Contract #: 04-0120F4Cty: SF/ALA Rte: 80 PM: 13.2/13.9File #: 69.25B**QUALITY ASSURANCE -- NON-CONFORMANCE REPORT****Location:** Changxing Island, Shanghai, P.R. China**Report No:** NCR-000534**Prime Contractor:** American Bridge/Fluor Enterprises, a JV**Date:** 10-Dec-2009**Submitting Contractor:** Zhenhua Port Machinery Company, Ltd (ZPMC), Changxing Island**NCR #:** ZPMC-0507**Type of problem:**

Reference Description: ZPMC performed base metal repairs without the Engineer's approval for Segment 7DW

Subject: NCR No. ZPMC-0507

Component: Segment 7DW Floor Beam FL3 Stiffeners

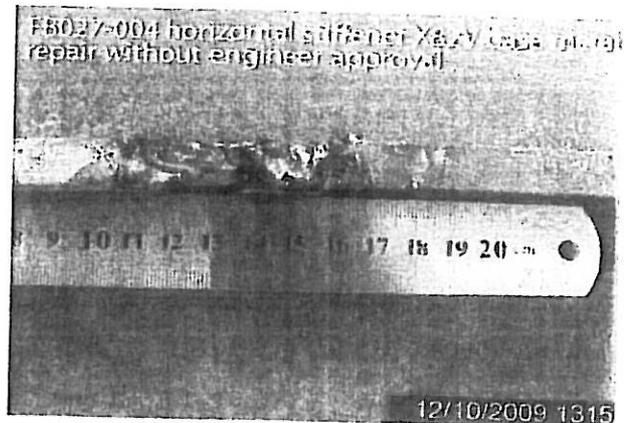
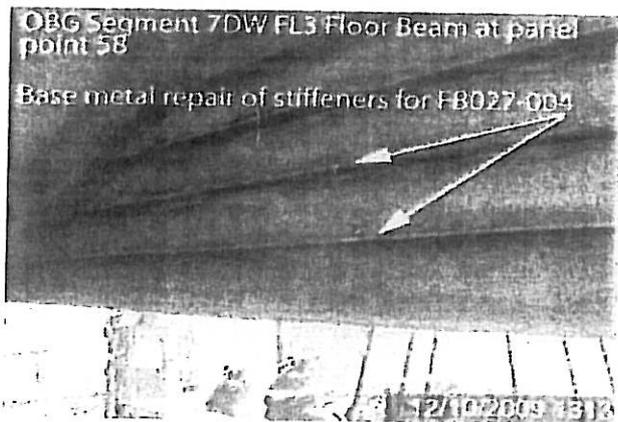
During a random visual inspection at OBG Segment 7DW of Floor Beam FL3 stiffeners, the Quality Assurance (QA) Inspector observed ZPMC performing un-approved base metal repairs on two (2) horizontal stiffeners located at FL3 Floor Beam PP58. Additional information about the non-conforming base metal repairs are listed below.

- 1) The Floor Beam is identified as: FB027-004
- 2) The 2 horizontal stiffeners are identified as: X82T and X82V
- 3) The welds were identified as: FB027-001,038/039 and FB027-001,040/041
- 4) ZPMC performed base metal repairs without the prior approval of the Engineer.

Special Provisions 8-3.01: "The Engineer shall be notified immediately in writing when welding problems, deficiencies, base metal repairs, or any other type of repairs not submitted in the WQCP are discovered and also of the proposed repair procedures to correct them. For requests to perform repairs,

The contractor shall include an engineering evaluation of the proposed repair.”
ZPMC Welding Quality Control Plan, Section 9.2.1.2: “Prior approval of the Engineer shall be obtained for repairs to base metal other than what was identified in Section 9.2.1.1 of this manual and the repair of all other cracks.”

AWS D1.5/2002, Section 3.7.4: “Prior approval of the Engineer shall be obtained for repairs to base metal, repair of major or delayed cracks, repairs to ESW and EGW welds with internal defects, or for revised design to compensate for deficiencies.”

This proposed resolution is acceptable. The documentation received is sufficient and the Department concurs that Non-Conformance ZPMC-0507 is closed.

Component: Segment 7DW Floor Beam FL3 Stiffeners

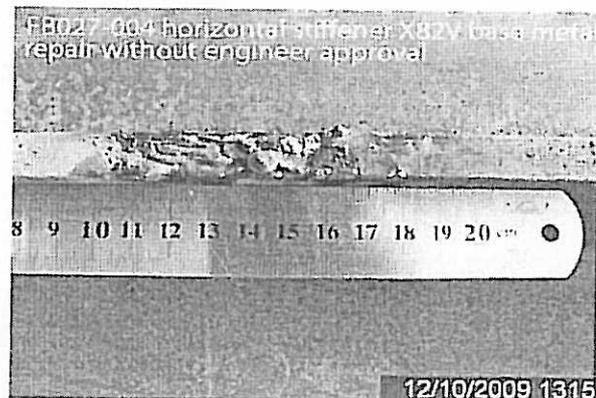
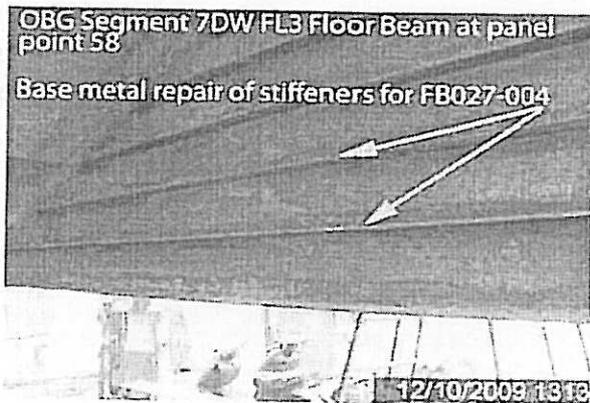
During a random visual inspection at OBG Segment 7DW of Floor Beam FL3 stiffeners, the Quality Assurance (QA) Inspector observed ZPMC performing un-approved base metal repairs on two (2) horizontal stiffeners located at FL3 Floor Beam PP58. Additional information about the non-conforming base metal repairs are listed below.

- 1) The Floor Beam is identified as: FB027-004
- 2) The 2 horizontal stiffeners are identified as: X82T and X82V
- 3) The welds were identified as: FB027-001,038/039 and FB027-001,040/041
- 4) ZPMC performed base metal repairs without the prior approval of the Engineer.

Special Provisions 8-3.01: "The Engineer shall be notified immediately in writing when welding problems, deficiencies, base metal repairs, or any other type of repairs not submitted in the WQCP are discovered and also of the proposed repair procedures to correct them. For requests to perform repairs,

The contractor shall include an engineering evaluation of the proposed repair.”

AWS D1.5/2002, Section 3.7.4: “Prior approval of the Engineer shall be obtained for repairs to base metal, repair of major or delayed cracks, repairs to ESW and EGW welds with internal defects, or for revised design to compensate for deficiencies.”

Contractor submitted NDT documentation verifying repairs meet Contract weld quality requirements.
